Accessibility Report

Adolfo Park

3601 Adolfo Road
Camarillo, CA 93010

11/30/2021

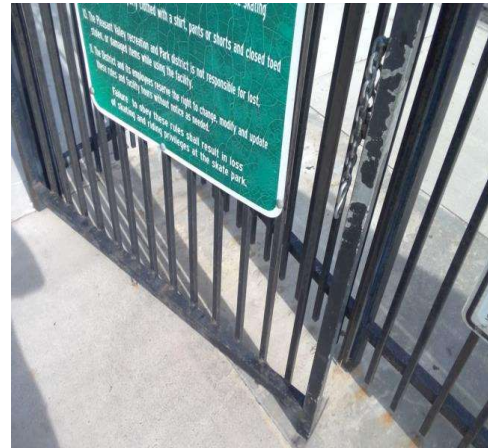
The bottom of the door or gate does not provide a smooth surface on the push side extending the full width of the door or gate.

Install a smooth uninterrupted surface or panel on the push side, extending the full width of the door or gate.

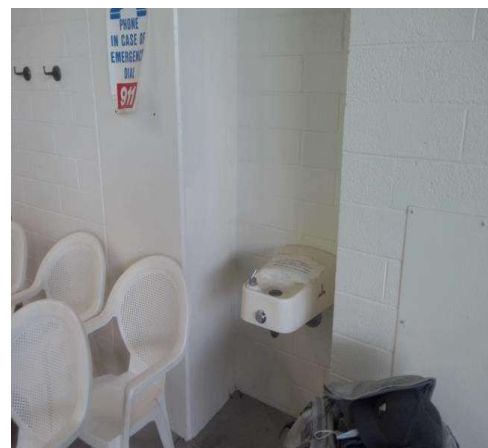
Adjust the flow of the water stream to a compliant height.

Recommendation At least 4.00 inches

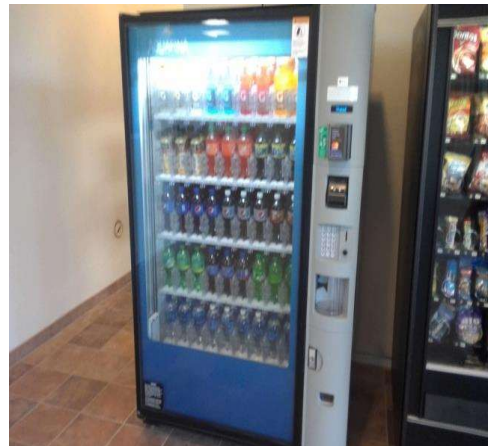
Contact the owner of the vending machines to obtain accessible vending machines.

Recommendation Up to 48.00 inches

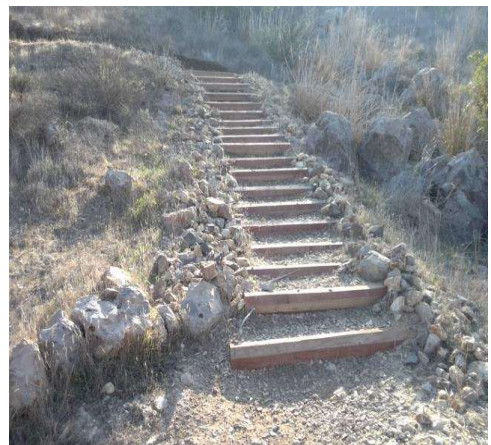
On-Site Finding See Above

Modify or replace the stairs to provide compliant treads.

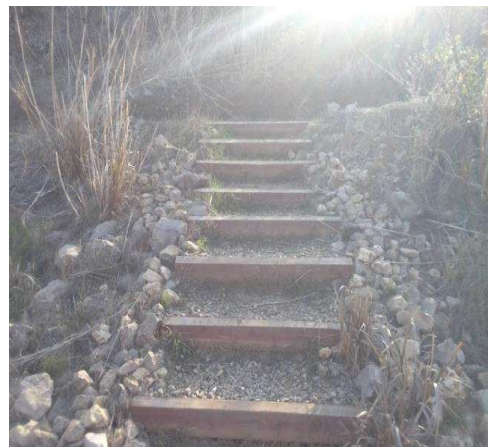
On-Site Finding Not Uniform

Modify or replace the stairs to provide uniform riser height.

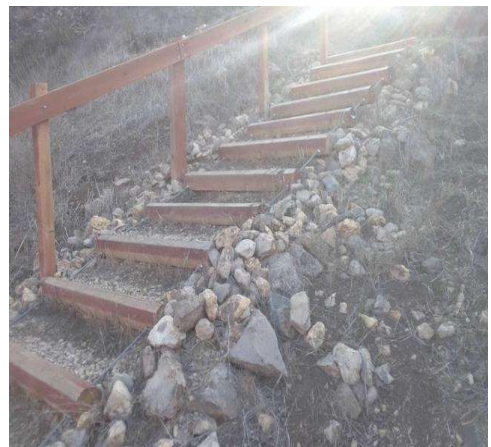
On-Site Finding None Found

Provide compliant striping to each tread of the stairway.

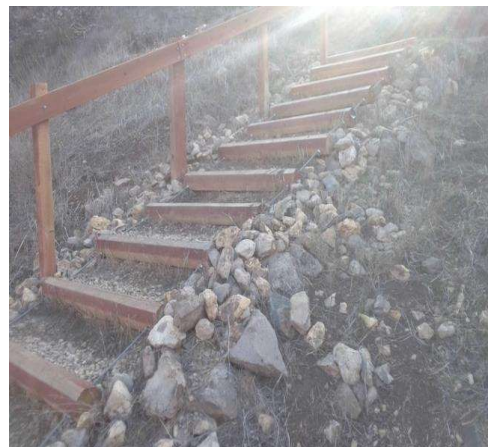
On-Site Finding None Found

Provide compliant handrails on the stairway.

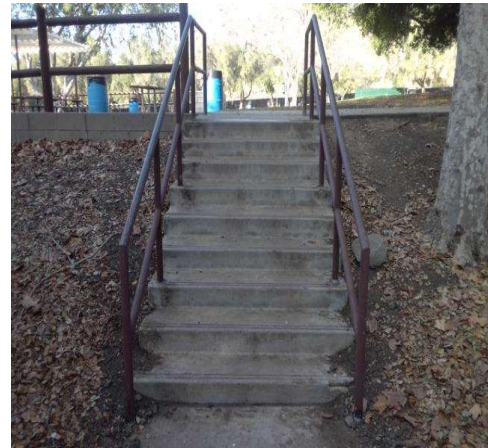
On-Site Finding None Found

Provide compliant striping to each tread of the stairway.

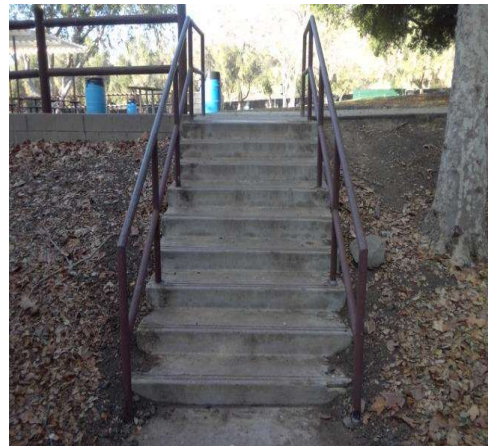
On-Site Finding None Found

Provide a compliant handrail extension.

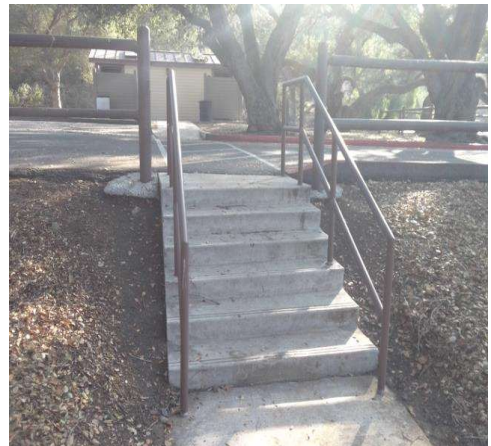
Install a compliant extension to the handrail.

Recommendation At least 12.00 inches

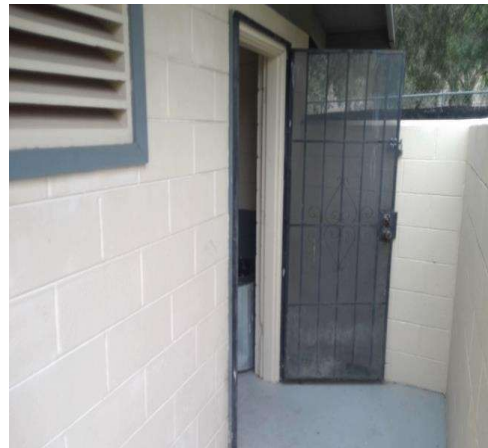
Widen the door opening and install a door that provides at least the minimum clear width with the door open 90 degrees.

Recommendation At least 32.00 inches

Elevated Equipment - Rubberized Surface

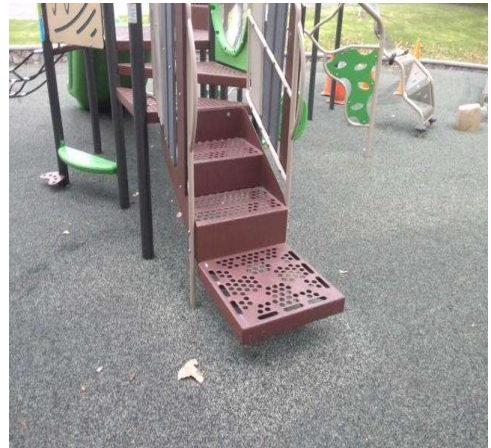
All risers are not closed.

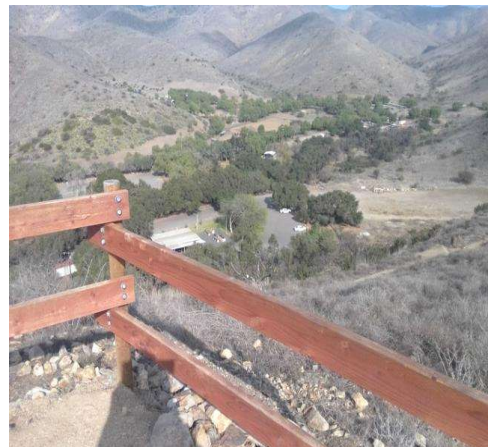
On-Site Finding Obstructed

Make sure that there is at least 32" of unobstructed view from floor.

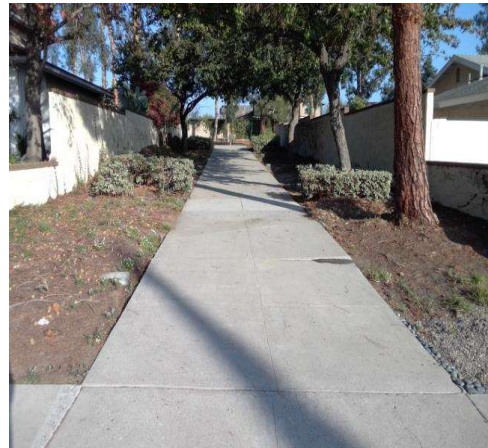
Ensure that the change in elevation is within the recommended value.

Recommendation Up to 0.25 inches

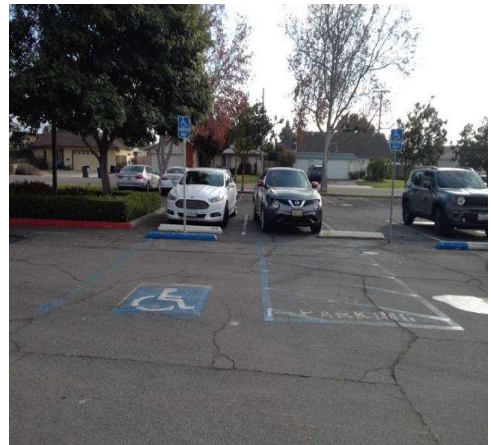
Repave the access aisle to provide a compliant surface slope.

Recommendation Up to 2.08 percent

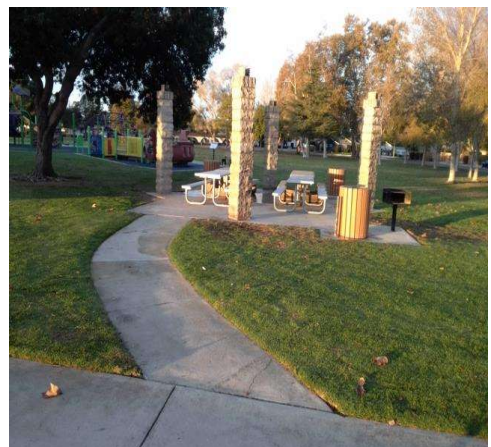
Widen the primary path of travel to provide the correct width.

Recommendation At least 48.00 inches

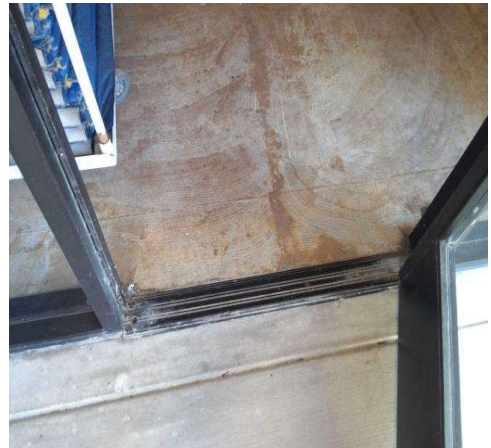
Modify or replace the threshold to provide the recommended height.

Recommendation Up to 0.50 inches

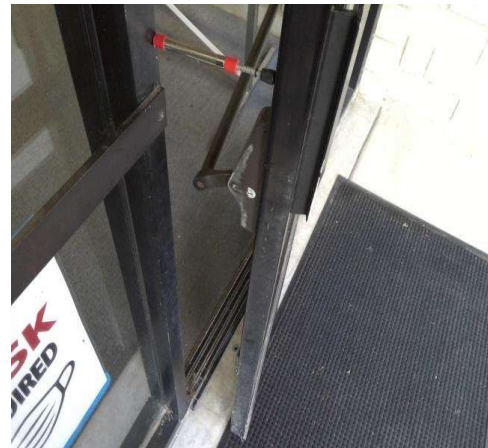
Adjust the closer on the door to meet the door opening force requirements.

Recommendation Up to 5.00 pounds

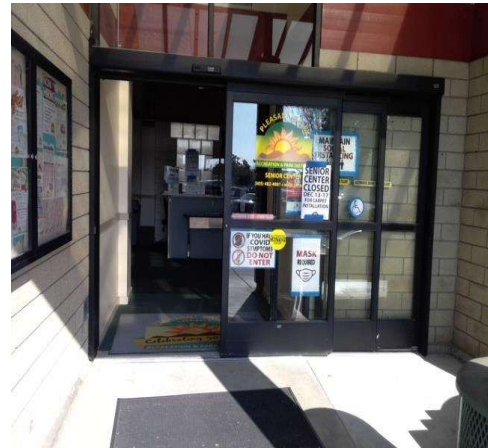
Adjust the automatic door so the force to stop the door from closing is no more than allowed.

Recommendation Up to 15.00 lbf

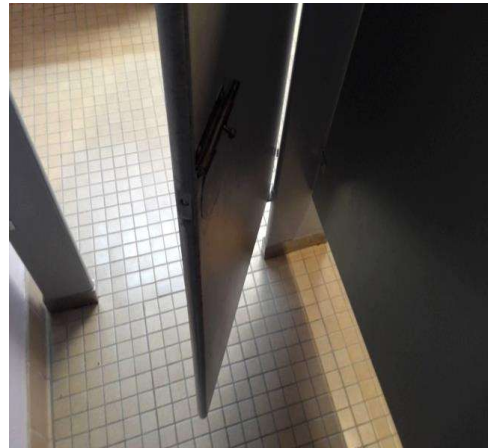
Widen the doorway to provide a compliant clear opening width when the door is open 90 degrees.

Recommendation At least 32.00 inches

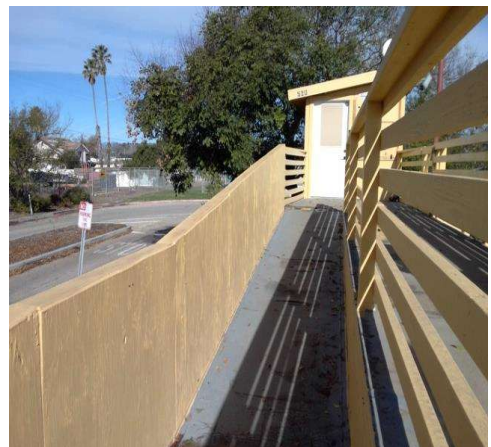
Widen the run of the ramp so that it has minimum required width.

Recommendation At least 48.00 inches

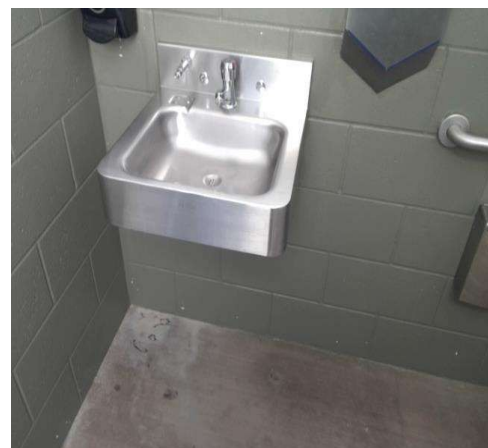
Replace or remount lavatory to meet the minimum required distance to the center line of the fixture, when located adjacent to a side wall or partition.

Recommendation At least 18.00 inches on center

Path from Mission Oaks Boulevard to Restroom Building/Concessions Stand

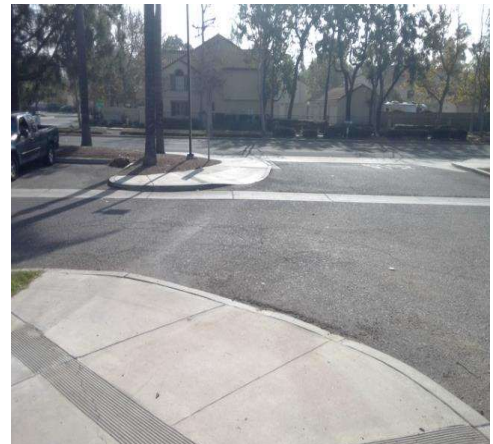
There are no detectable warnings where the pedestrian route crosses vehicular traffic.

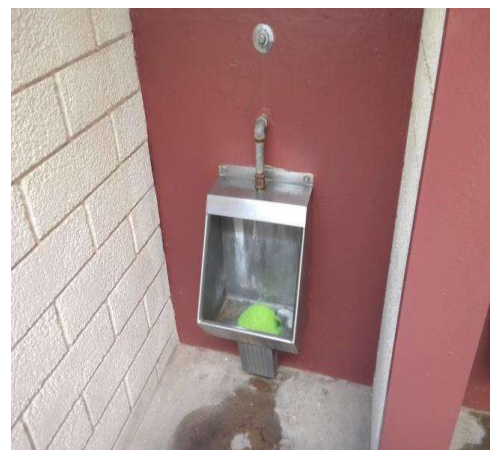
Lower the urinal designated to be accessible in the restroom so that the rim height is compliant.

Recommendation Up to 17.00 inches

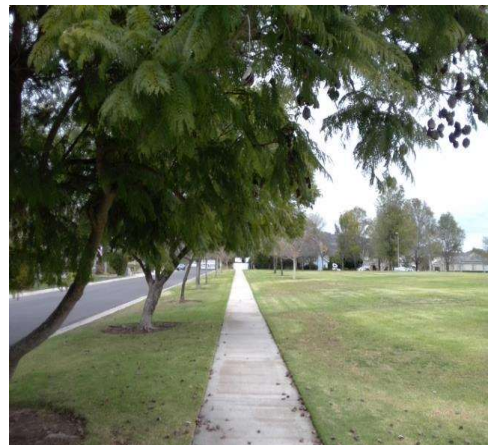
Provide recommended vertical clearance.

Recommendation At least 80.00 inches
